CLEARFIELD CITY COUNCIL
AGENDA AND SUMMARY REPORT
July 20, 2021 - POLICY SESSION

Planning Commission

Attn: Brad McIlrath, Senior Planner
Proj: **Java Express**
Subj: Review #1

2 MONUMENT SIGN (BY OTHERS)
SCALE: 1/16" = 1'-0"

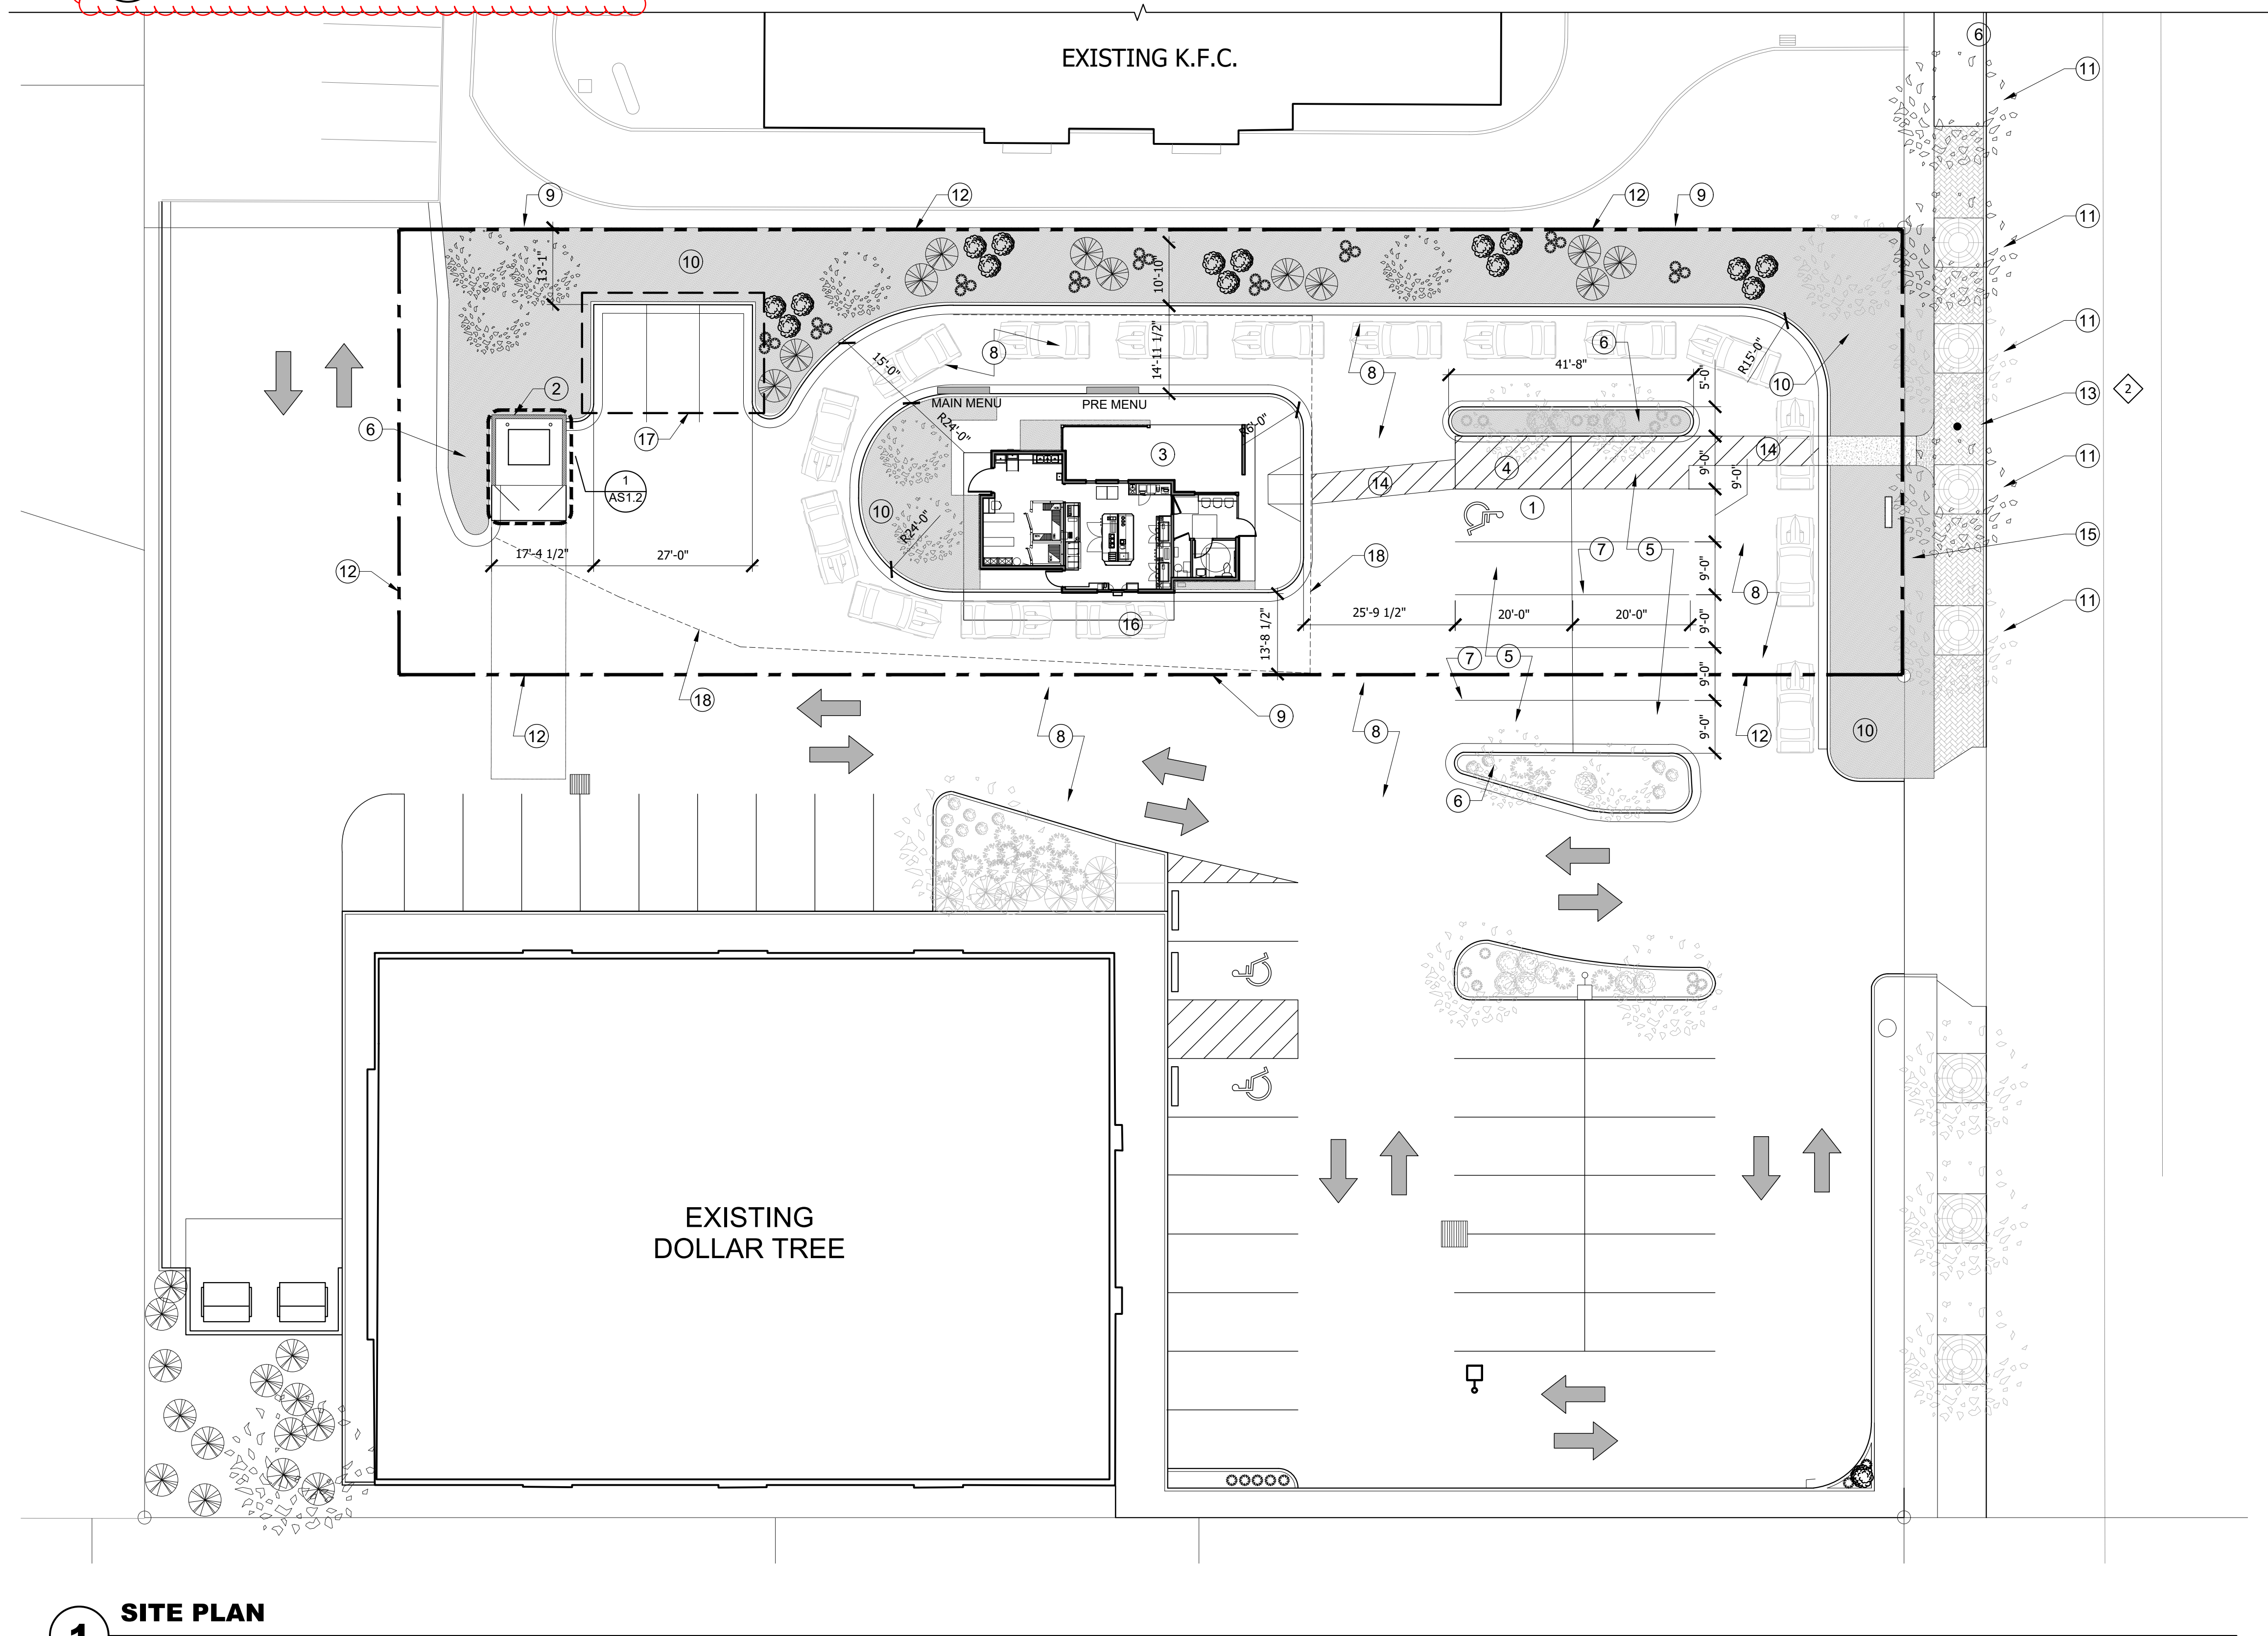
Monument signs are allowed in Clearfield. This sign would be a pole sign, which is not permitted. Need to replace.

1 SITE PLAN
SCALE: 1/16" = 1'-0"

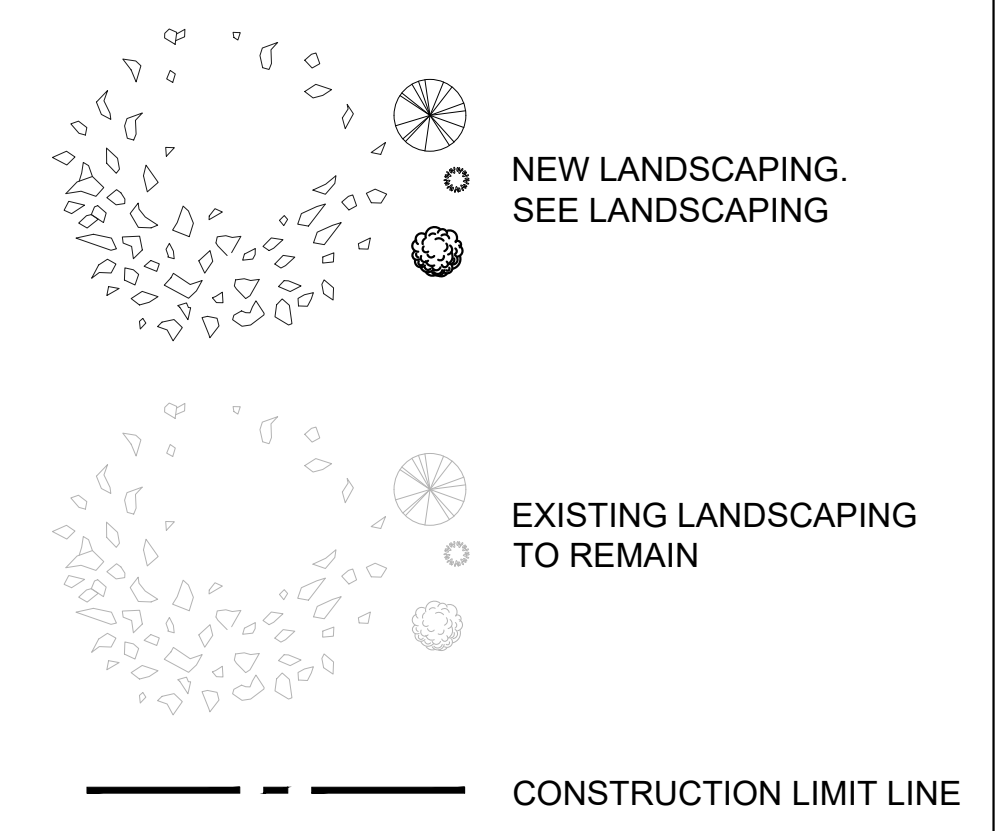
- 2) The plans shall be revised to provide one (1) double acorn streetlight within the buffer area between the two center street trees as required by code.

- 4) The site shall be designed, and the plans revised to have no more than seventy percent (70%) of impervious coverage and no more than twenty percent (20%) semi-pervious coverage.

- 10) A total of ten (10) on premises trees shall be provided and shown on the revised landscape plans.
- 11) A minimum five foot (5') wide planting strip shall be placed around the footprint of the building except in areas used for entrances, the drive-through or the outdoor dining area.

- 13) The parking lot area in the rear yard shall be provided with the parking lot buffer along the north property line as required by code.
- 14) The landscape island located at the north end of the free-standing row of parking within the front yard shall be revised to have a minimum width of five feet (5') and extend the length of the parking stalls as required by code.
